FOREST CO SURVEYOR  
FILE # 341328-20020301  
DATE \_\_\_\_\_ BY \_\_\_\_\_

PART OF THE NORTHWEST QUARTER OF THE NORTHWEST QUARTER OF SECTION 28,  
T34N-R13E, TOWN OF NASHVILLE, FOREST COUNTY, WISCONSIN. ALL THAT PART OF VOLUME  
231, PAGE 158 AND 159 LYING EAST OF THE CENTERLINE OF CRANE LAKE ROAD.

SCALE: 1" = 50'  
DATE: FEBRUARY 11, 2002  
REVISED: MARCH 1, 2002

FAX TRANSMITTAL

KAMPS OFFICE MAP NUMBER

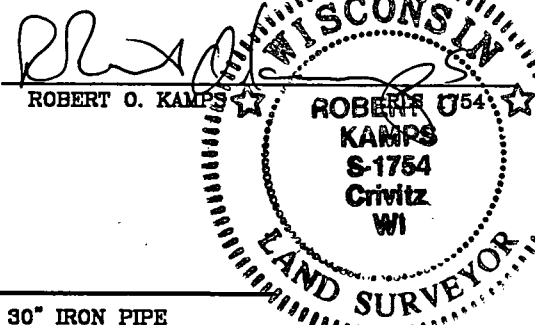
AFTER WE COMPLETED YOUR SURVEY, JOAN COOK-RECK  
ASKED ME TO DO SOME ADDITIONAL WORK FOR HER  
TO THE EAST OF YOUR PARCEL. AS A RESULT OF  
THAT WORK WE DISCOVERED THAT THE BANDOR  
YIG CORNER WAS NOT IN THE CORRECT PLACE. THE  
PIPE WE FOUND FOR YOUR NE CORNER WAS ON A  
STRAIGHT LINE FROM THE NORTHWEST SECTION CORNER  
TO THE BANDOR YIG CORNER (AN AXEL SHAFT).

WE SET THE YIG CORNER IN IT'S PROPER POSITION  
AND THEN RESET YOUR NE CORNER, NOW 4.24'  
NORTH OF THE FOUND PIPE. WE REVISED OUR  
MAP AND I AM PROVIDING YOU WITH A REVISED  
COPY. PLEASE CALL WITH ANY QUESTION.
